**SUBJECT: FINAL PROJECT WORK PLAN, INSTALLATION RESTORATION SITES 5 AND 10,  
BUILDINGS 5 AND 400 STORM DRAIN AND SEWER LINE, TIME-CRITICAL  
REMOVAL ACTION, ALAMEDA POINT, ALAMEDA, CALIFORNIA**

FINAL PROJECT WORK PLAN  
INSTALLATION RESTORATION SITES 5 AND 10,  
BUILDINGS 5 AND 400 STORM DRAIN AND SEWER LINE,  
TIME-CRITICAL REMOVAL ACTION

**RESPONSE TO COMMENTS ON  
DRAFT PROJECT WORK PLAN  
FOR IR SITES 5 AND 10 (BUILDINGS 5 AND 400) STORM DRAIN AND SEWER LINE  
TIME-CRITICAL REMOVAL ACTION  
FORMER NAVAL AIR STATION ALAMEDA  
ALAMEDA POINT, ALAMEDA, CALIFORNIA  
(DATED MAY 29, 2007)  
DCN: ECSD-RACIV-07-1211**

Figure 1-3

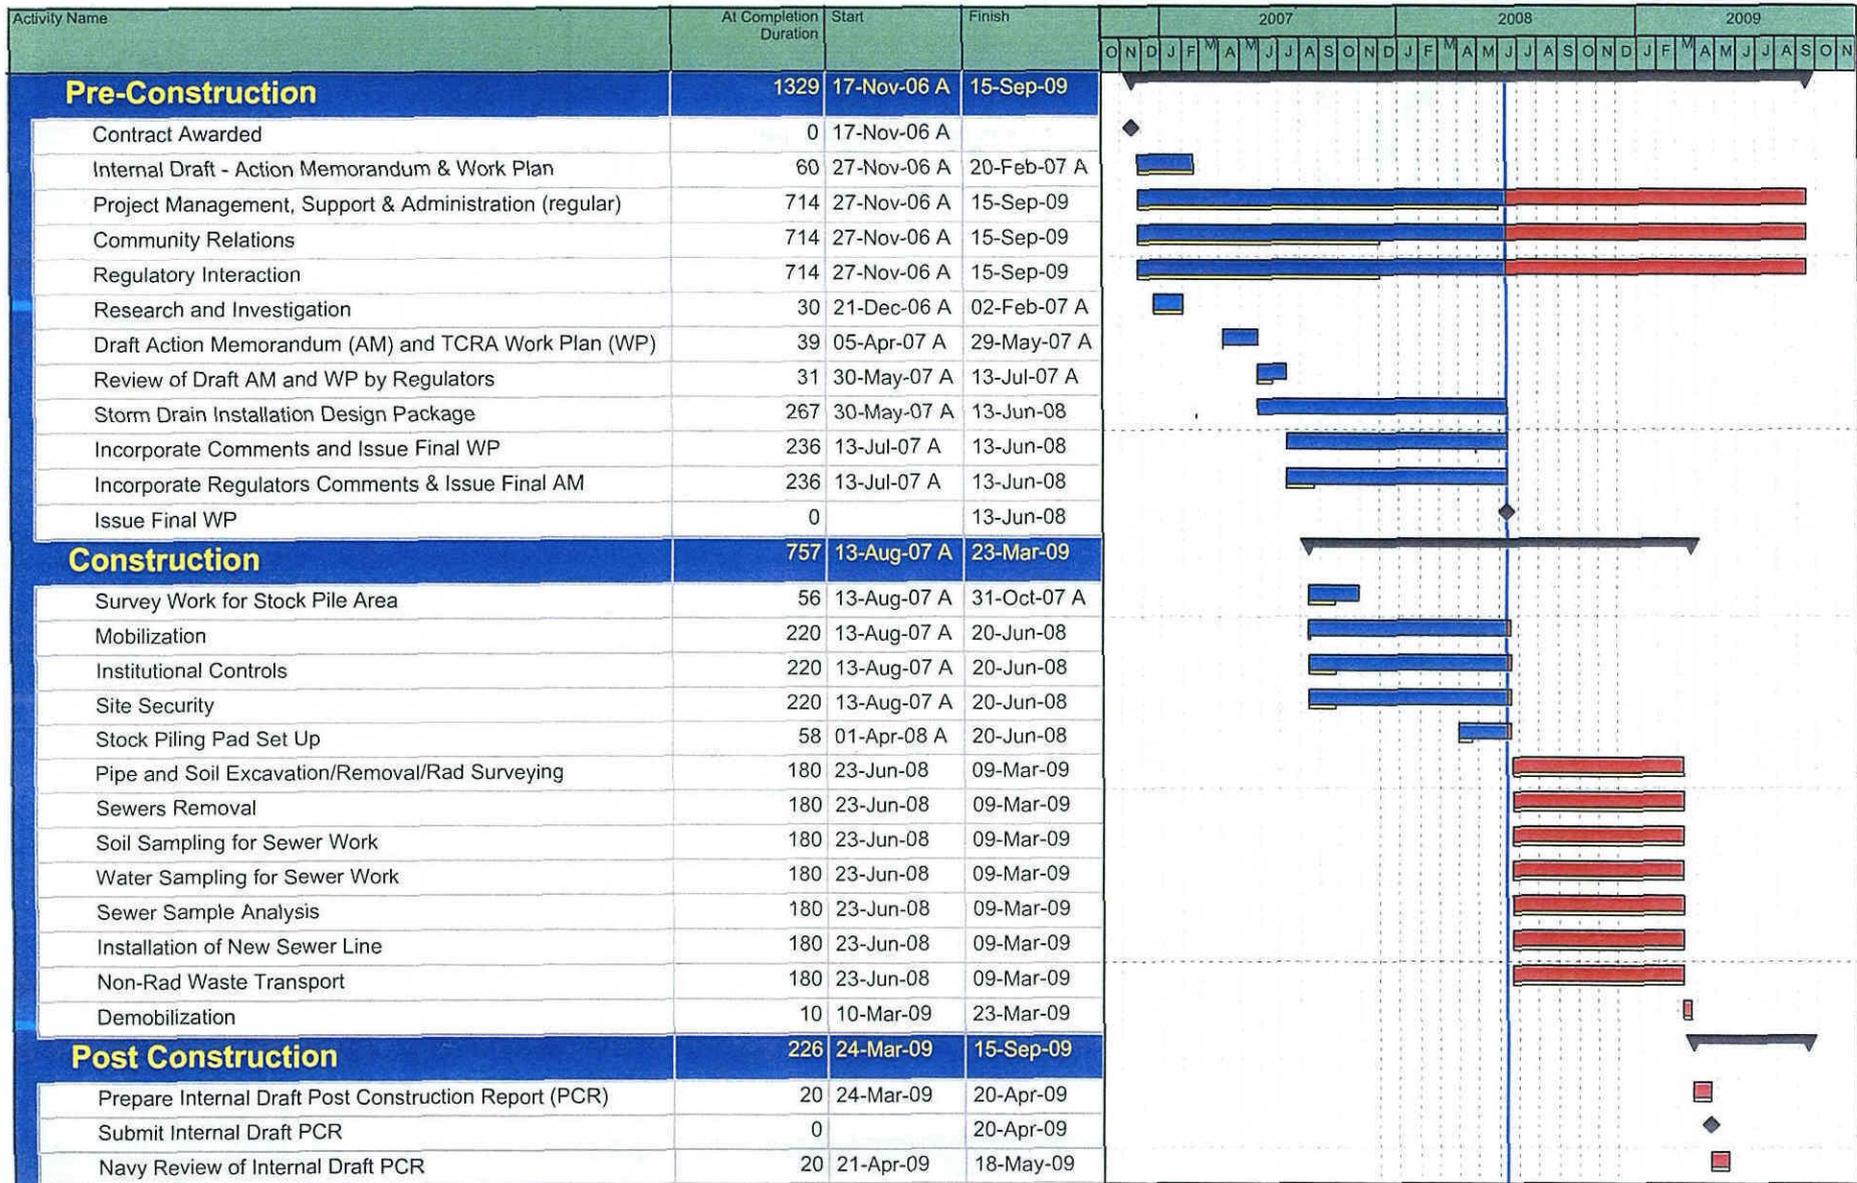
**Comment 2.** Appendix G does not provide an implementation schedule. As such, the sequence of tasks and proposed commencement/completion dates and timeframes cannot be evaluated. For example, it is unclear if trench excavations will occur simultaneously or sequentially. It is also unclear if multiple pumping stations will be operated simultaneously as

**Project Schedule:** The project schedule has been updated. See attached Figure 1-3.

Figure 6-1  
 SHEET 1 OF 2  
**STORM DRAIN SYSTEM**  
 OU-2C, IR SITES 5 AND 10  
 ALAMEDA POINT - ALAMEDA, CA

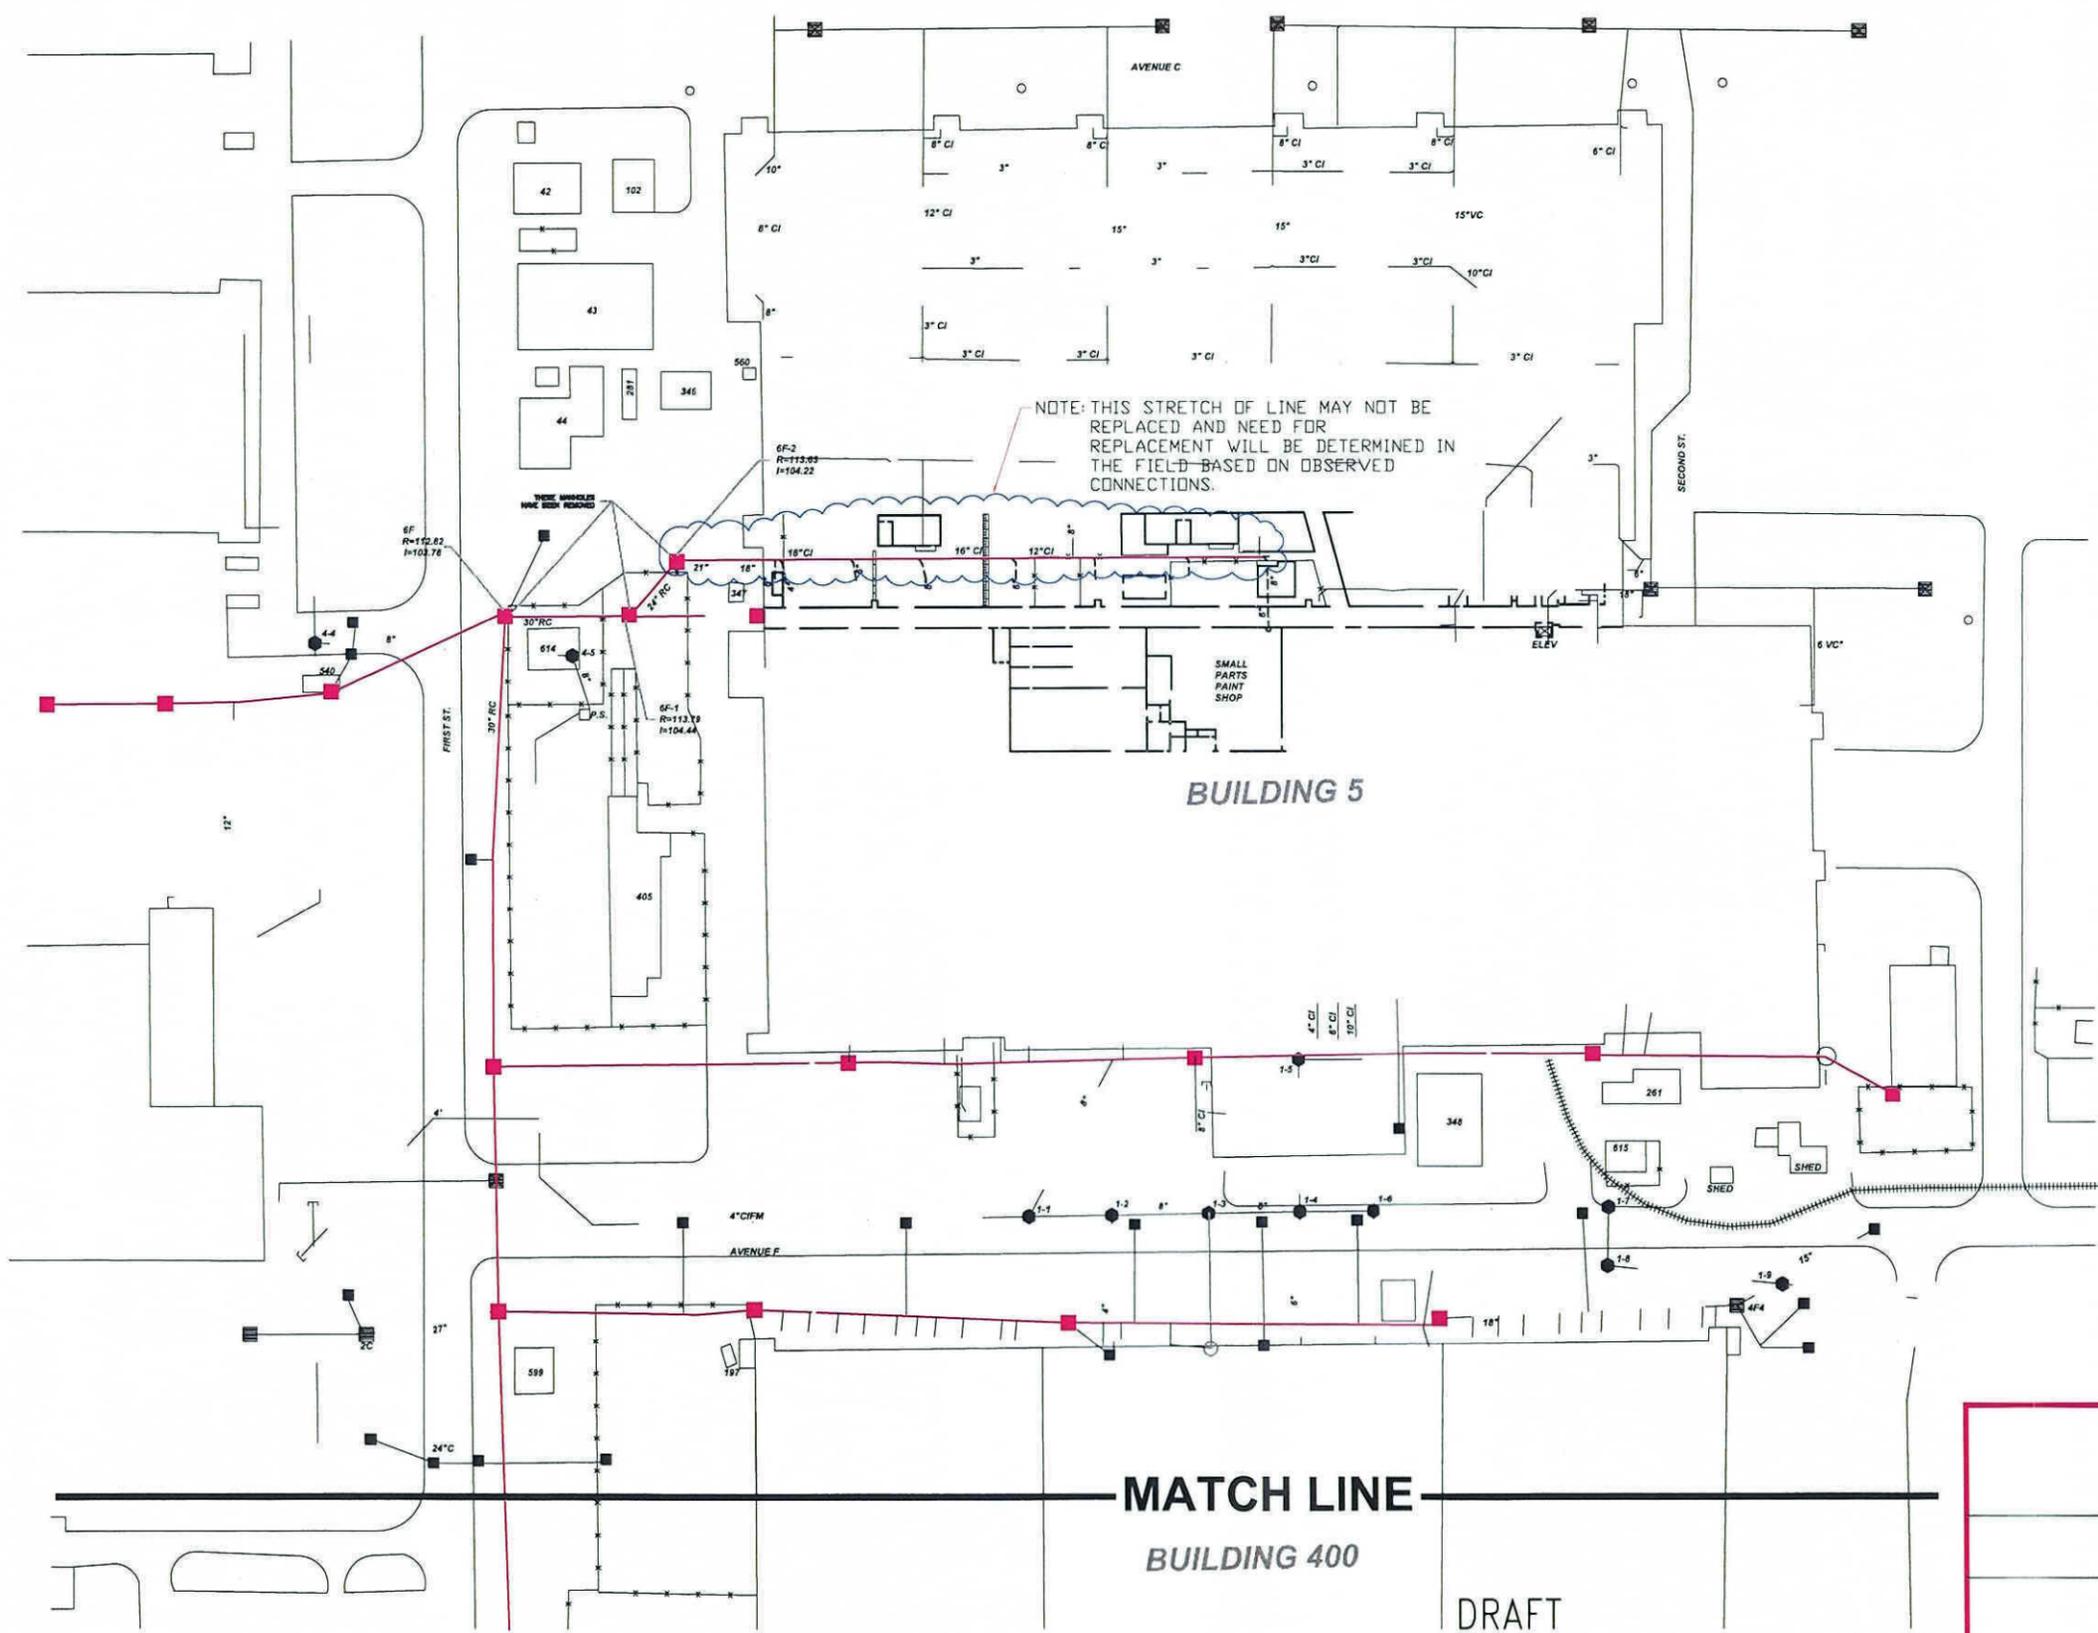
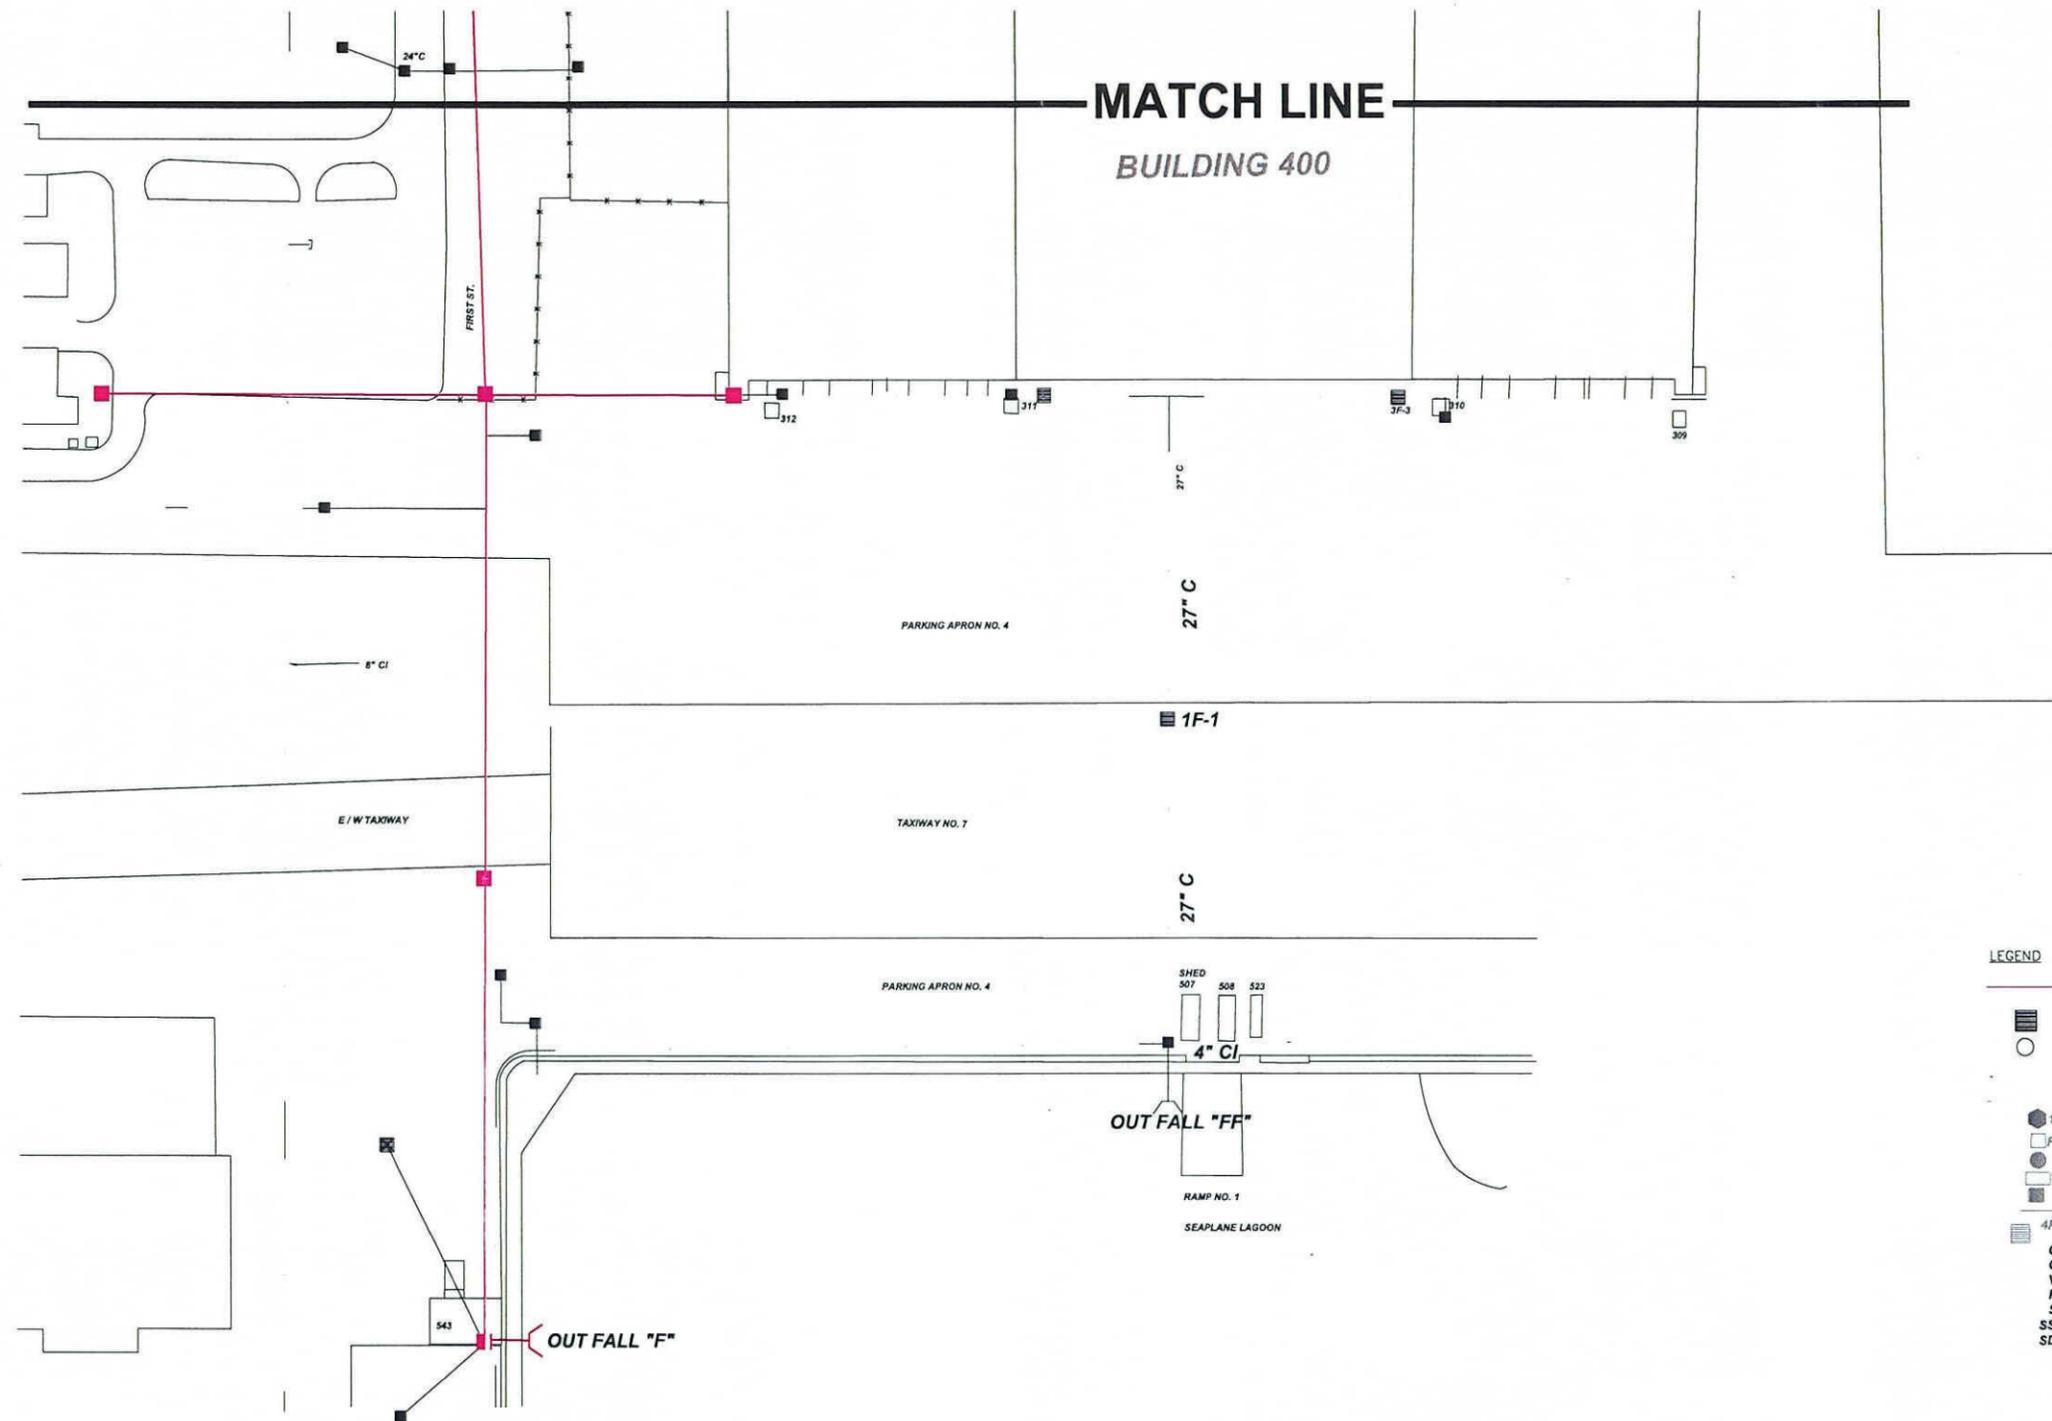
COMMENTS	RESPONSE
<p><b>Comment 1.</b> How much, if any, of the pipeline would be removed from inside Building 5?</p>	<p><b>Response 1.</b> Currently, the line(s) inside the building running between Buildings 5 and 5A (drainage primarily from the former small parts paint shop) is planned for removal; the text and figures in the draft Work Plan did not consistently depict this. The figures will be revised in the final Work Plan, as necessary, to consistently indicate that this line will be addressed during the TCRA. See attached revised Figure 6-1 showing the lines proposed for removal.</p>

**Comment 2.** Mr. Russell indicated he had a question about the lines north of Building 5A. Ms. Wheaton said those lines were not part of the TCRA scope. Mr. Russell referred to the draft Work Plan, Appendix G, Drawing 0028-101, Sheet 1 of 6, where those lines appeared to be depicted as part of the project. Mr. Russell asked if these lines came from inside the building. Ms. Wheaton said she was not sure and would research the lines origins. In addition, she would clarify if they should be part of the TCRA scope.

**Response 2.** Research of historical documents and maps was performed and these lines have not been identified as radiologically contaminated in previous storm drain line investigations conducted by the Navy. The lines north of Building 5A and northeast of Buildings 5/5A were not intended to be part of the original proposed work and were erroneously depicted as part of the removal action on the figure referenced in Comment 2. The figures will be revised so these lines are consistently not designated for removal in the final Work Plan. See attached revised Figure 6-1 showing the lines proposed for removal.
